Questions and Answers

Computerized Maintenance Management System RFP Specification No. PI25-0148F

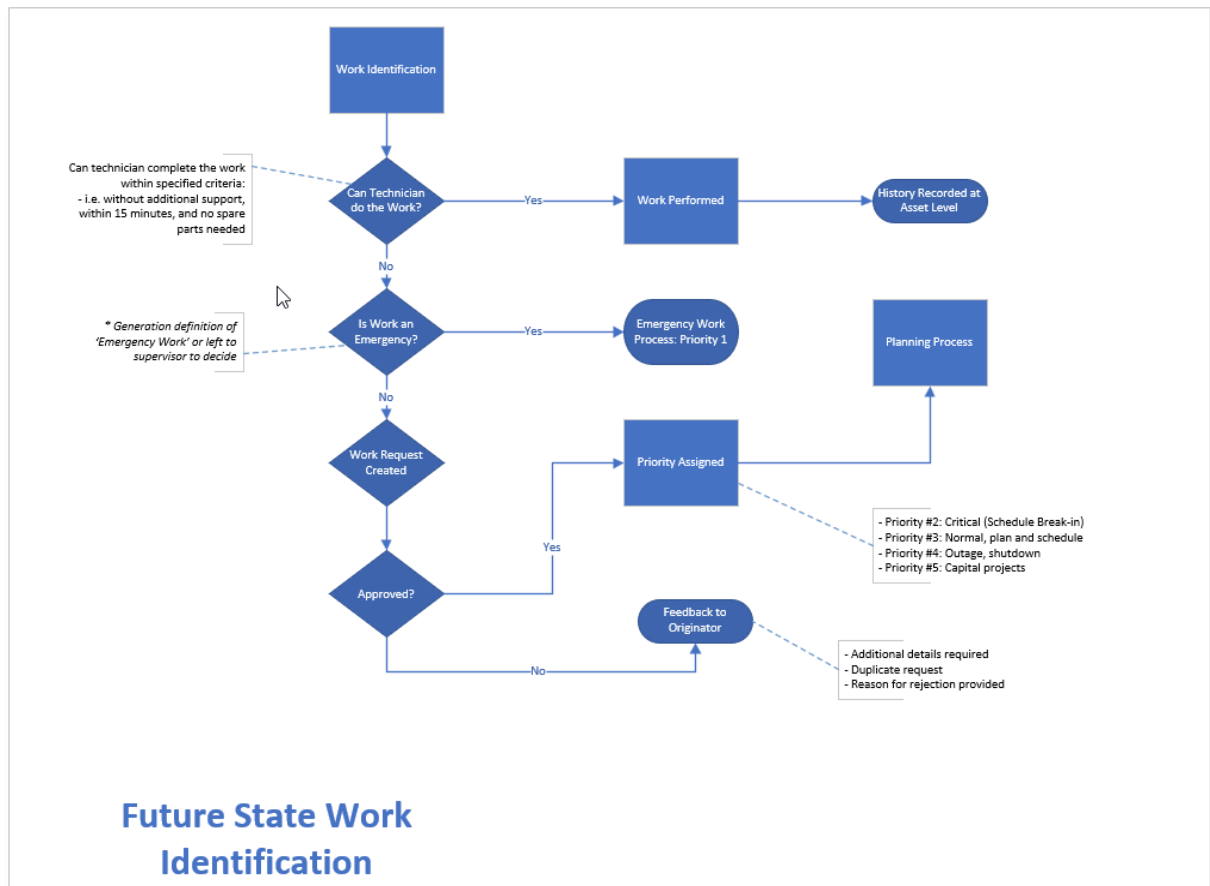
28. Question: Section 4.1.3 - Can you provide a high-level example of a typical Work Request approval workflow, including the number of tiers and roles involved?

Answer: Currently there is one to two levels of approval. These processes are currently in development and subject to change.

Sample workflow identification and approval provided below:

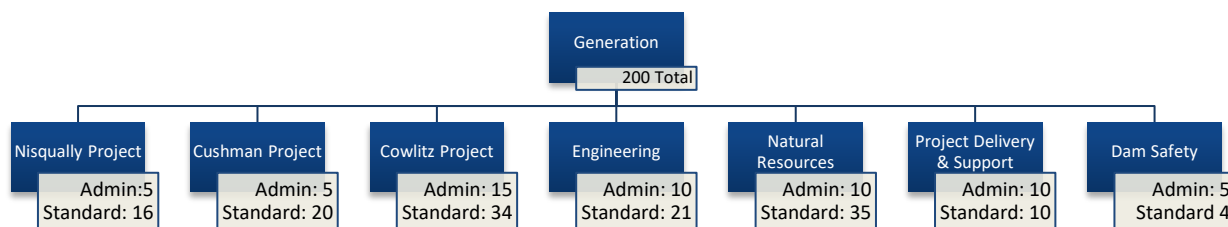
66. Question: Can you provide an organizational chart for the departments/divisions that are targeted to use the EAM?

Answer: Tacoma Power, Generation is made up of multiple workgroups with a total of about 200 people. Of those about 60 are expected to have administrative level access to the CMMS and 140 would need standard user access. A high-level organization chart is provided with user breakdown per work group. A detailed organization chart will be provided to the selected vendor.
